TWC: EVALUATION OF HECLA ROSEBUD
PROJECT ORE RESERVE MODEL 5/31/95

To: Ron Clayton, Hecla Mining Company

From: Don Earnest, Bill Oppenheimer, Rick Sims *DFE WLO*

Subject: Evaluation Of The Hecla Rosebud Project Ore Reserve Model

A PORTION OF CROSS SECTION 800 N
HIGH GRADE GOLD INTERCEPTS

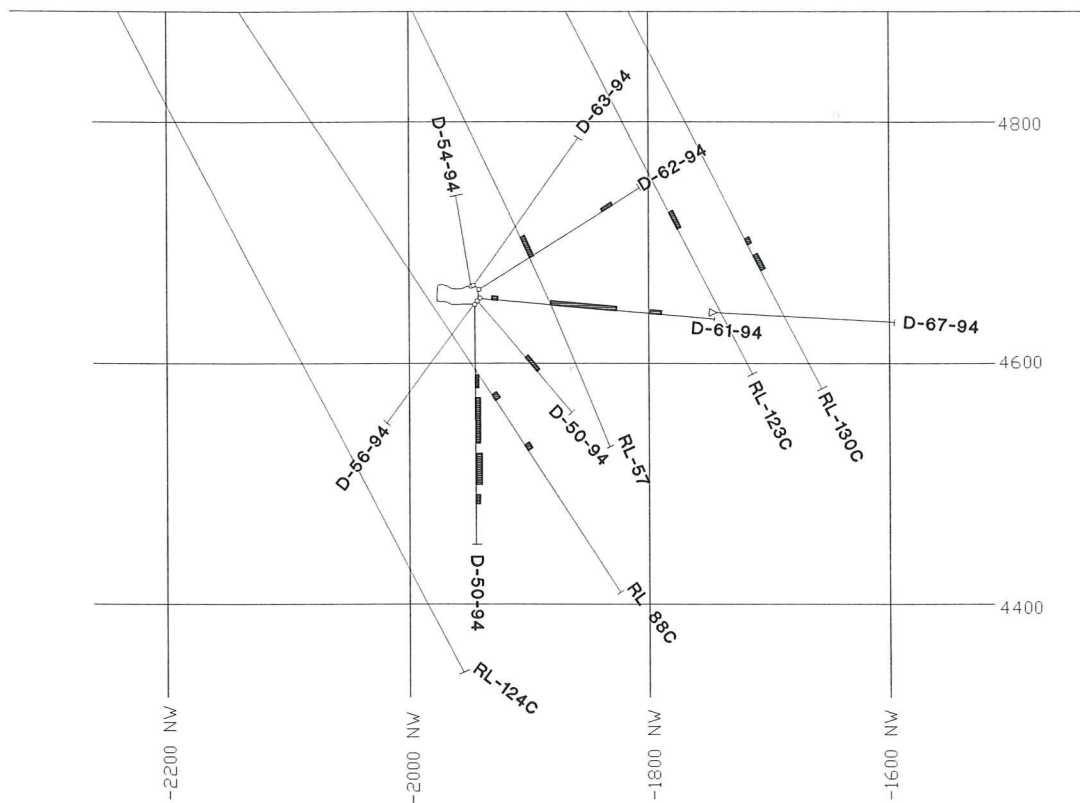
in cross section. For example, Figure 1 shows that on cross section 800 North several drill holes cut intercepts of mineralization higher than 0.50 opt Au. The 50-foot long horizontal intercept in drill hole D-61-94 is crossed by drill hole RL-57 which indicates no significant mineralization is present at the point of intersection of the two holes. Likewise, a 20 foot-long high-grade intercept in drill hole RL-57 is not corroborated in adjacent holes D-63-94 and D-62-94. In TWC's opinion, this indicates that locally **within domain boundaries** high grade gold intercepts may not be projectable for distances greater than 20 feet.

pg 7 We threw out RL-57: could not verify coordinates; assays & geology didn't match surrounding drill holes.

REVISIONS				<u>THE WINTERS CO.</u> 6125 E. GRANT RD. TUCSON, AZ 85712	HECLA ROSEBUD PROJECT	TITLE:	A PORTION OF THE 4605 BLOCK MODEL LEVEL PLAN SHOWING THE LOCATION OF COMPOSITE ASSAYS SCALE 1"=40'-0"
						DOCUMENT NO.	Figure 2
	NO.	DATE	DESCRIPTION

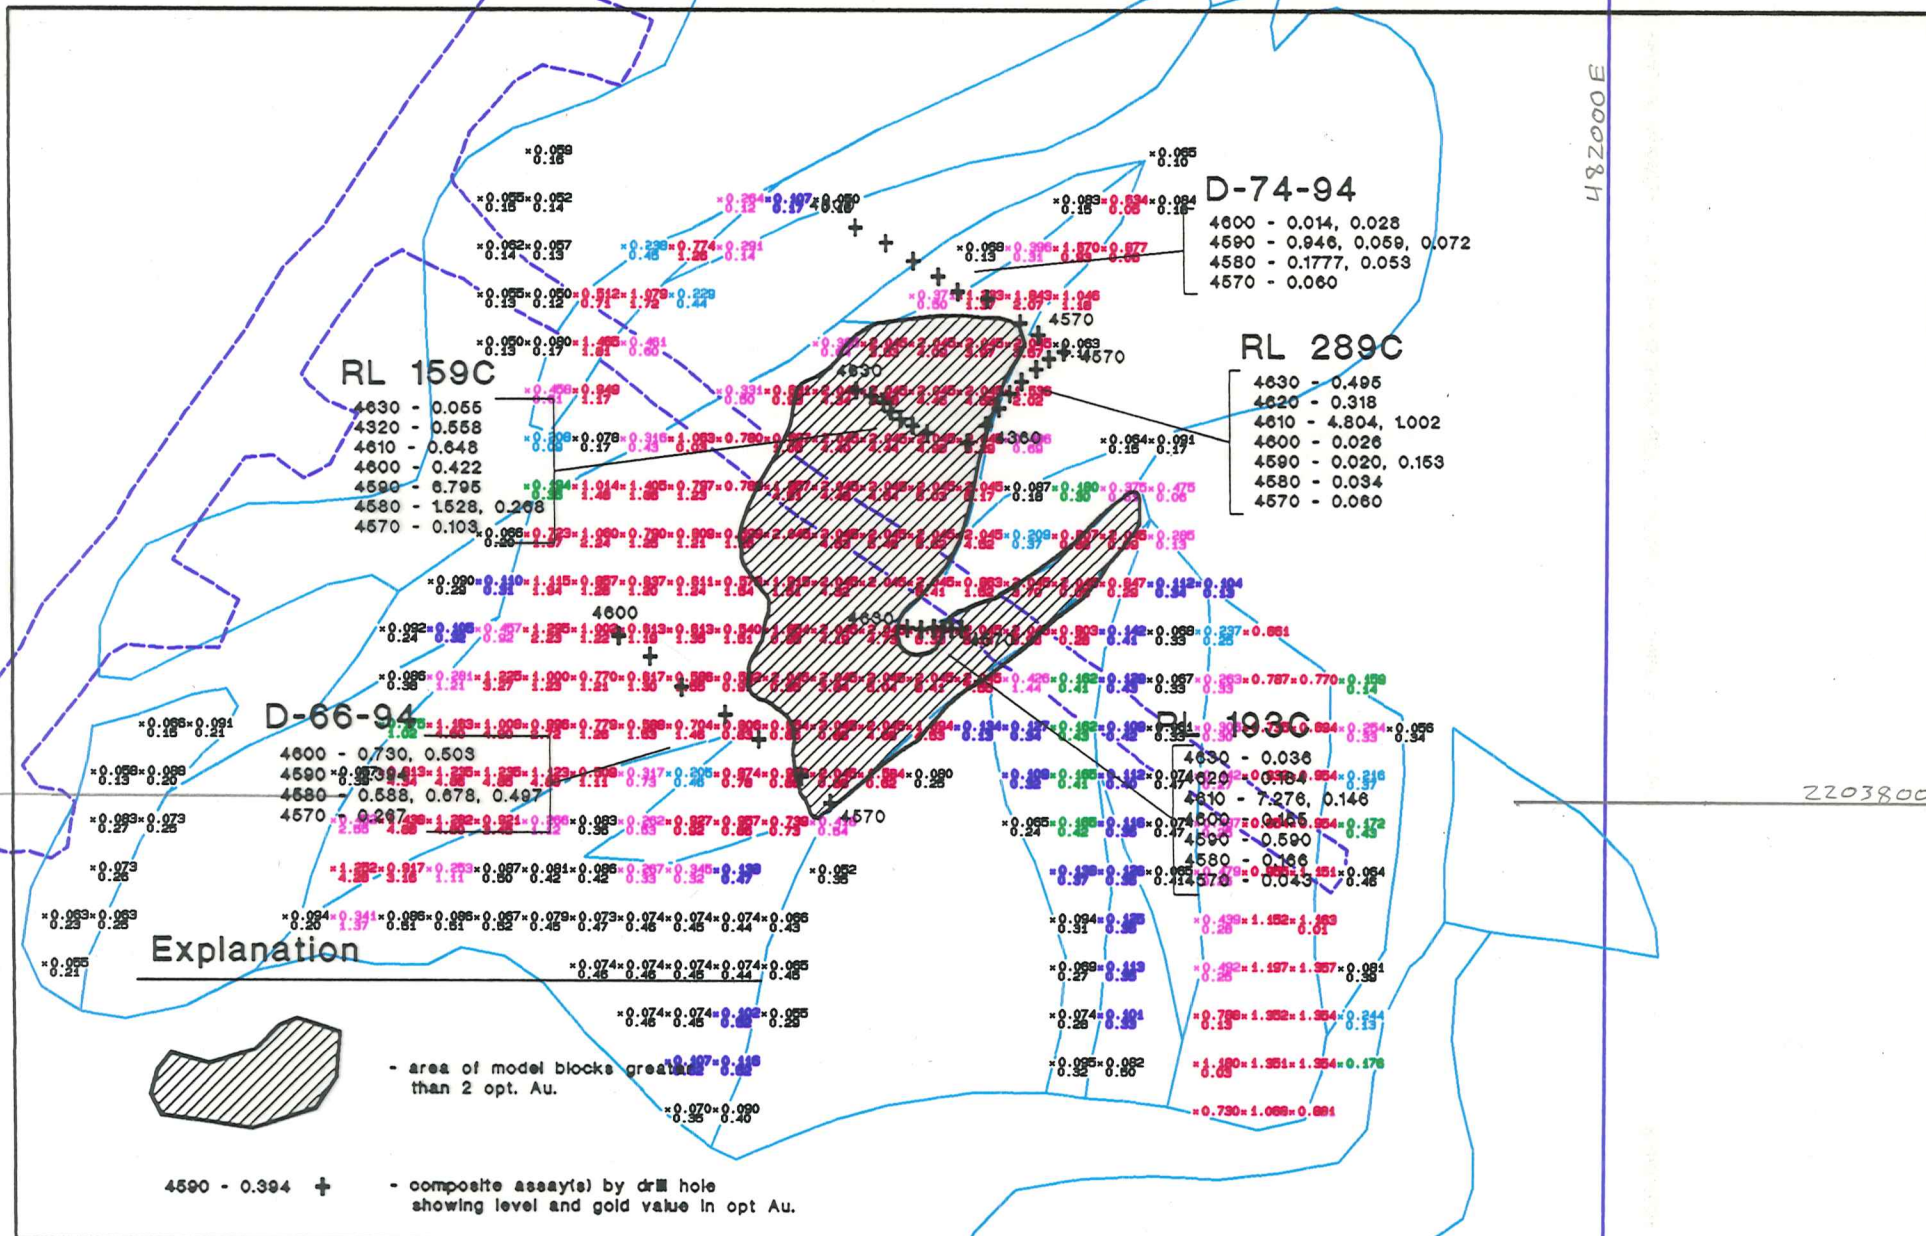
The level plan comparisons also indicated areas where a small number of high-grade intervals appear to account for disproportionate high grade ore tonnages. On level 4600 at coordinates 2,203,850 north and 481,850 east, 38 contiguous model blocks contain gold grades of at least 2.045 ounces per ton (Figure 2). There are only three composite assays within 60 feet vertically (+/- 30 feet) from the 4600 level with gold grades higher than 2.045 opt that could contribute to the high grades estimated for these 38 blocks. These composites are immediately adjacent to composites of substantially lower grade in the same drill holes. In this example, the number of high grade blocks appears to be heavily influenced by the small number of high grade composites. TWC believes that in this case, the isolated high grade composites must be more tightly restricted to limit their influences upon ore block estimations within the domain boundary. The drill hole spacing within the domain boundary in this area is approximately 50 feet. TWC believes that in local areas containing extremely high grade intercepts such as this one, Hecla geologists must further restrain the allowable

projection limits of this high grade material either by manual editing or empirical judgment.

PART OF CROSS SECTION 450 N

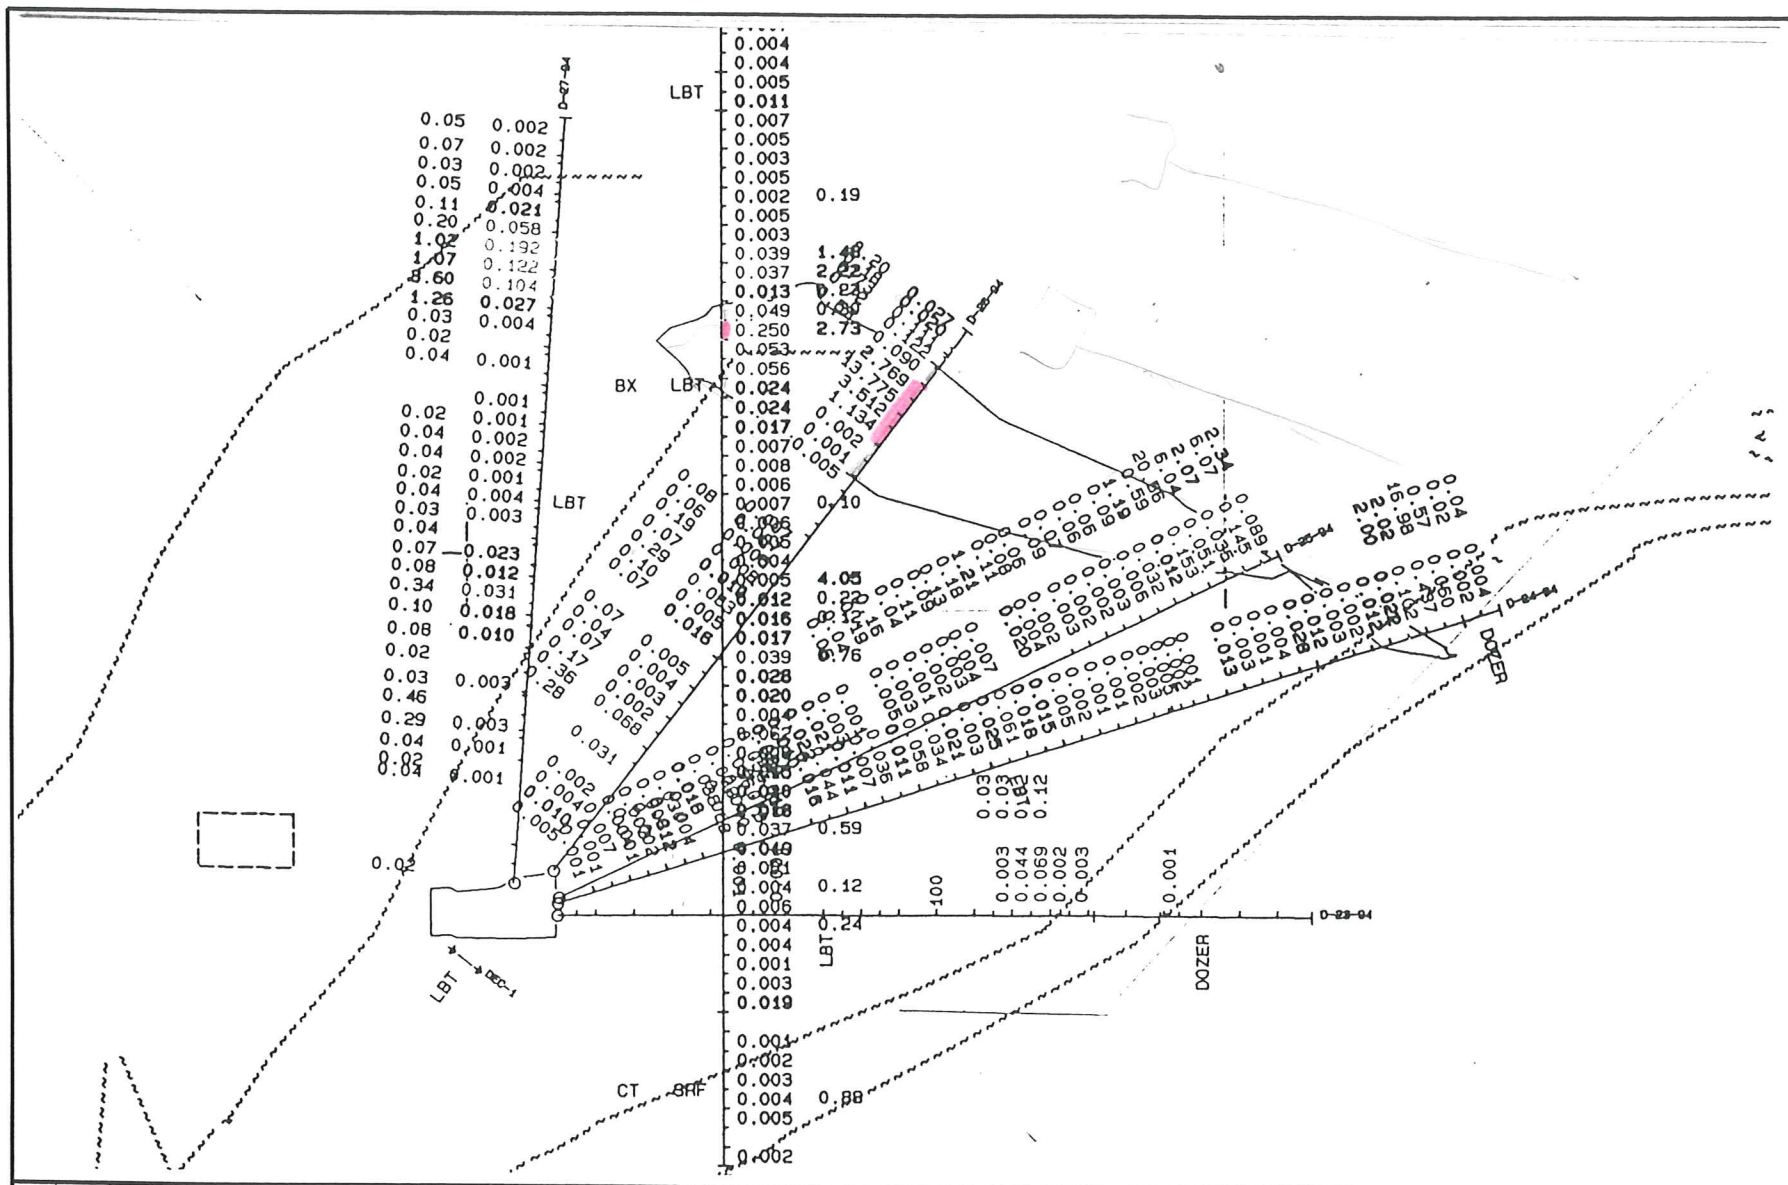
Similarly, on cross section 450 North on the 4850 level, drill hole D-26-94, contains an interval of 15 feet with a gold grade of 5.2 ounces per ton (Figure 3). During composite calculation, this interval was split between two contiguous composites with gold grades of 8.0 and 2.0 ounces per ton (Figure 4). The 15 feet long interval directly above the high grade intercept averages 0.075 ounce gold per ton. The 40 feet below the high grade intercept average 0.003 ounce gold per ton. The nearest drill hole, RL-35, is 40 feet to the northwest and contains one interval measuring five feet with a gold grade of 0.250 ounce per ton. To the southeast the nearest hole is 80 feet away and contains no significant gold mineralization. On the 4830 level near the high grade interval in drill hole D-26-94, TWC notes that 21 out of 25 model blocks in Domain 4 contained gold grades above 2.045 ounces per ton. On the 4840 level, 22 out of 24 model blocks in Domain 4 contained gold grades above 2.045 ounces per ton (Figure 5). As in the previous example, TWC is concerned about the possible local overestimation of high grade ore tonnage around this high-grade drill intercept.
